# Responses to CEC Data Requests – Nos. A181 through A217

## Amended Application for Certification for HYDROGEN ENERGY CALIFORNIA (08-AFC-8A) Kern County, California

**RESPONSES TO DATA REQUESTS A181 THROUGH A217  
FROM CALIFORNIA ENERGY COMMISSION (CEC)**

**Photograph 2.** Point 2 of PG&E line (Line C, far left) and SCE lines (Lines D, right) facing southeast.

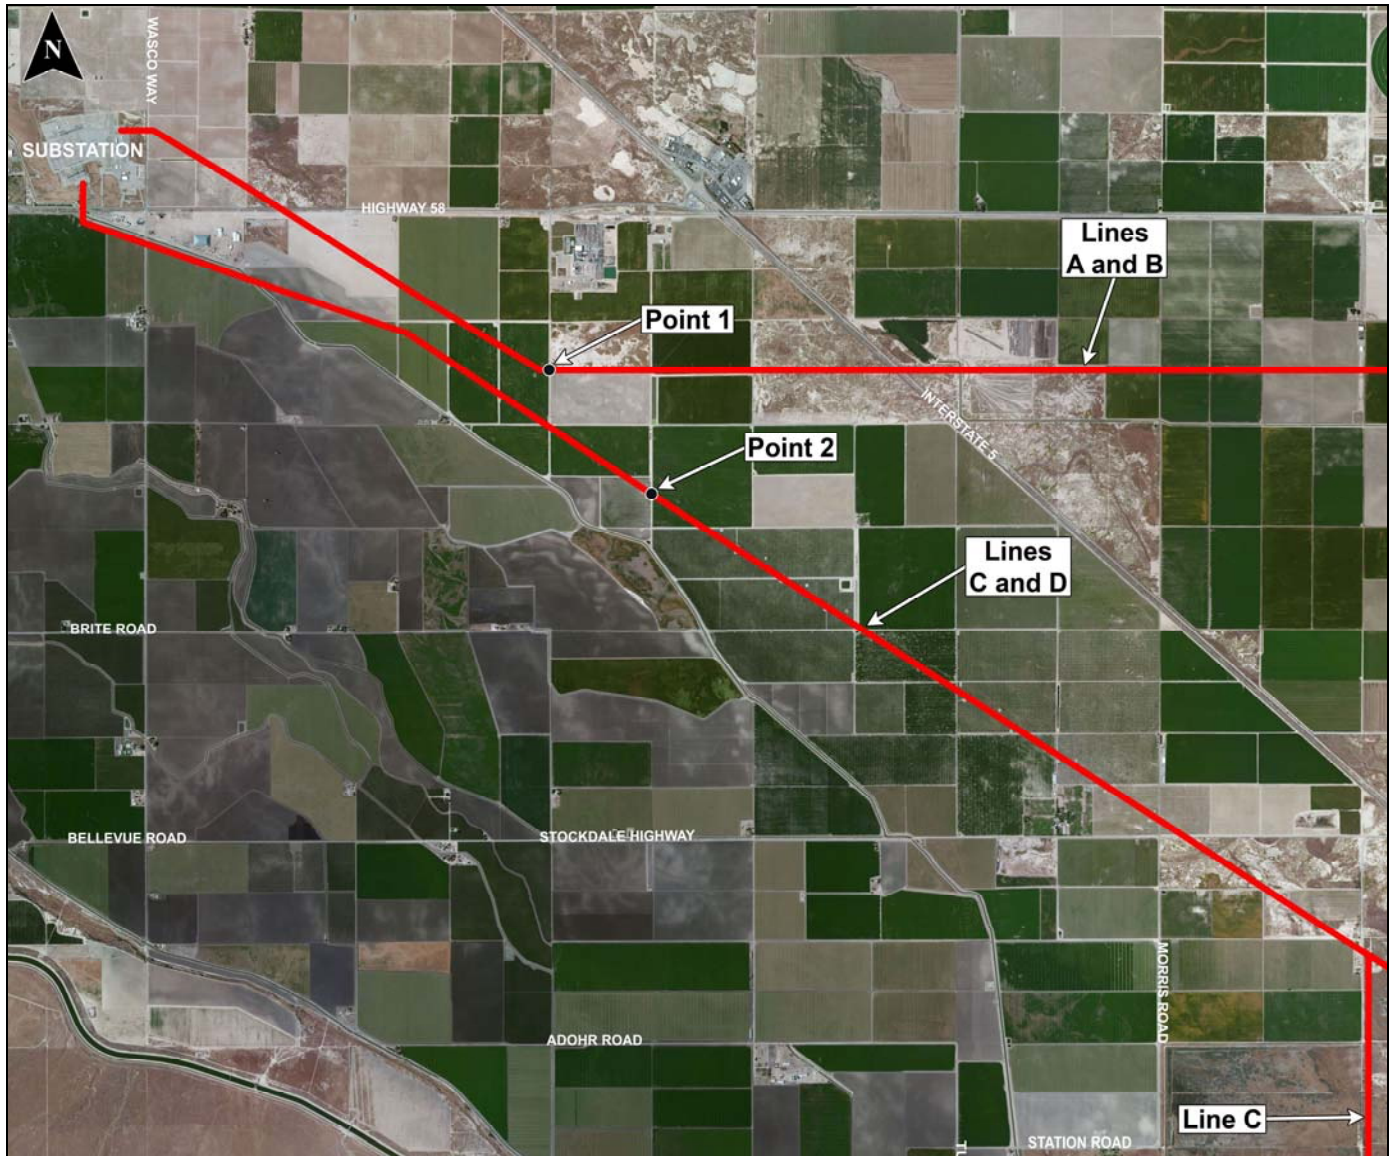
- a. Label photos on the previously submitted DPR 523 form and indicate on a sketch map where they were taken. Confirm that the photo locations are within the revised PAA. If not, provide updated photographs of the lines and towers within the PAA and clearly marked locations on a map.**

The Department of Parks and Recreation (DPR) 523 form for Map Reference 3 has been revised to include a sketch map showing where photos presented in the form were taken. The photos presented in the revised DPR 523 form are within the current Project Area of Affect. The revised DPR 523 form is included as Attachment A182-1.
